Re Application 2016/6426/P - Flat A 13 Crossfield Road London NW3 4NS

We wish to object to the proposals set out in planning application 2016/6426/P, at Flat A 13 Crossfield Road on behalf of our clients, who are neighbouring residents at No. 37 Adamson Road (full details attached at the bottom of this letter). We set out the detail of our objections below.

Figs. 1 and 2: Photos showing large mature tree to rear garden of No.37 Adamson Road

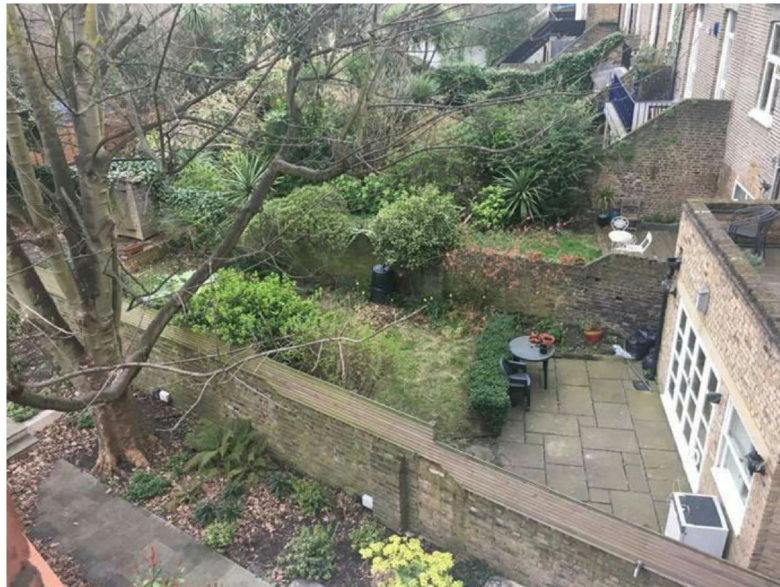
We also note that no arboricultural report or survey has been submitted with the application, despite the presence of a large mature tree to the rear of No. 37 Adamson Road which clearly has amenity value and makes a positive contribution to the conservation area (see figs. 1 and 2 below). The proposed excavation would clearly have some impact on the roots of this tree, but there is no detail on the extent of this impact, and how this tree would be protected during works. In the absence of this information, its potential loss would be clearly detrimental to the visual amenities of the area.
